Title: Arm - Power		UW Robotics 200 University Avenue Waterloo Ontario Canada N2L 3G6	
Size: Letter	Drawn By: Kyle Hong, Lance Bantoto		
Date: 2020-11-05	Sheet 1 of 7		
File: C:\Users\lance\GitHub\MarsRover2020-PCB\Projects\Arm\Rev2\SH1 - POWER.SchDoc

Title: Arm - CAN Transceivers

Title: Arm - Claw Sensor

Mounting Holes

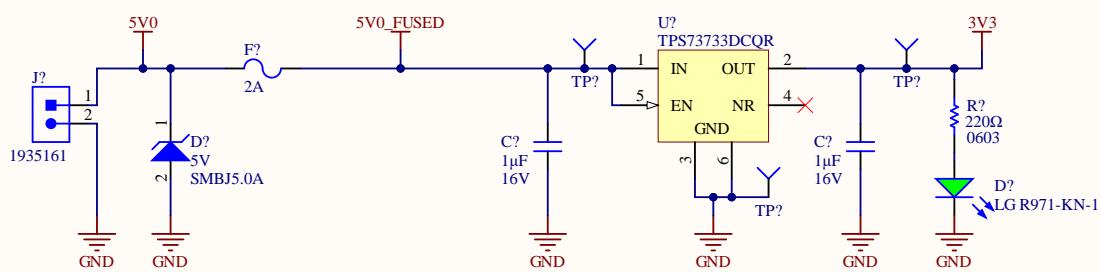
Need to make new mounting hole part depending on Andrew's fastener choice

STM32F446VET7

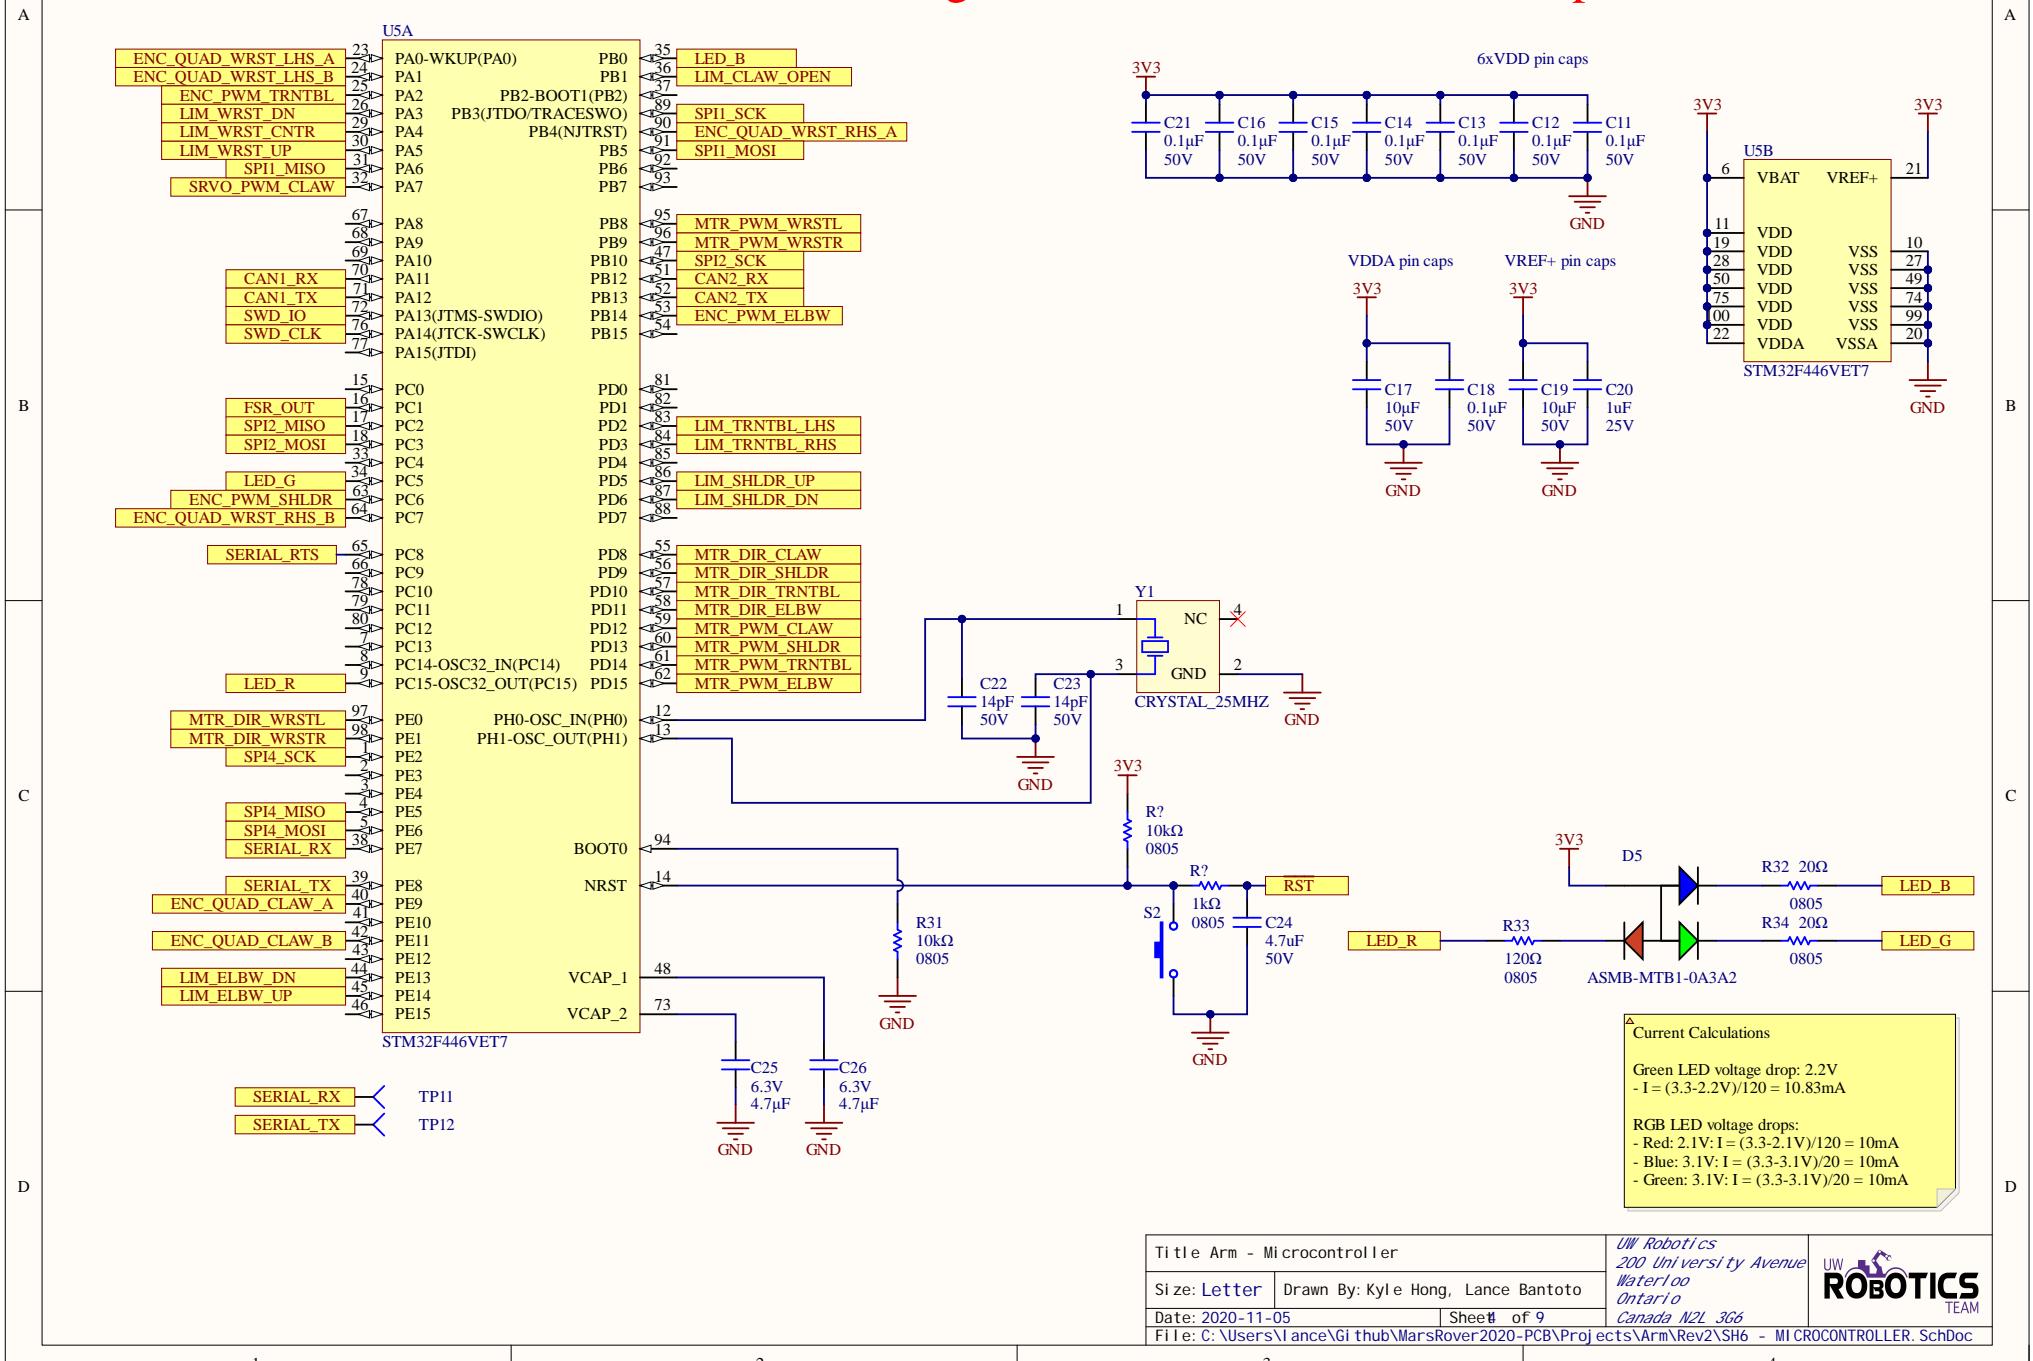
Configure one more SPI bus and CS pins

Broadcom Encoders

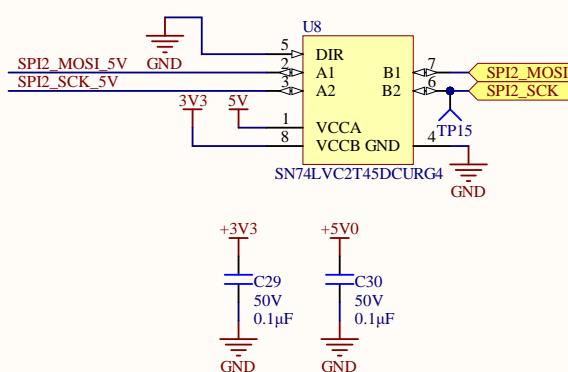
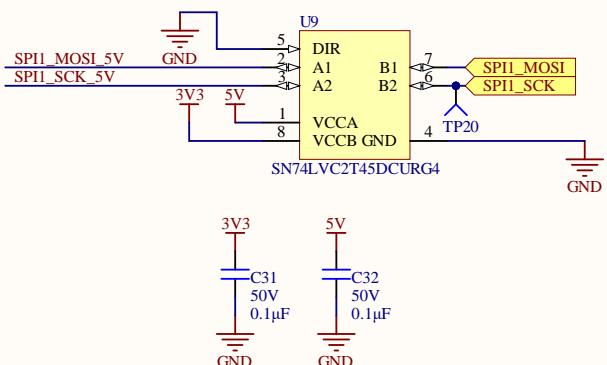
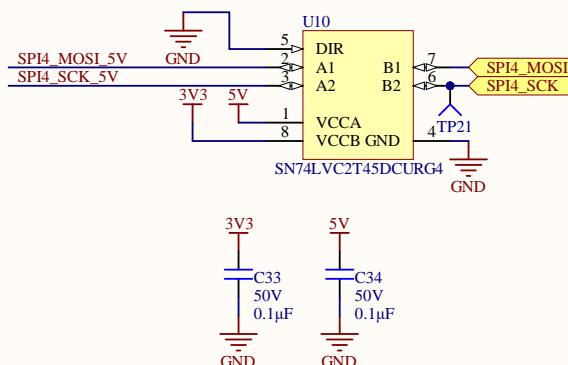
Change level shifters and remove MOSI
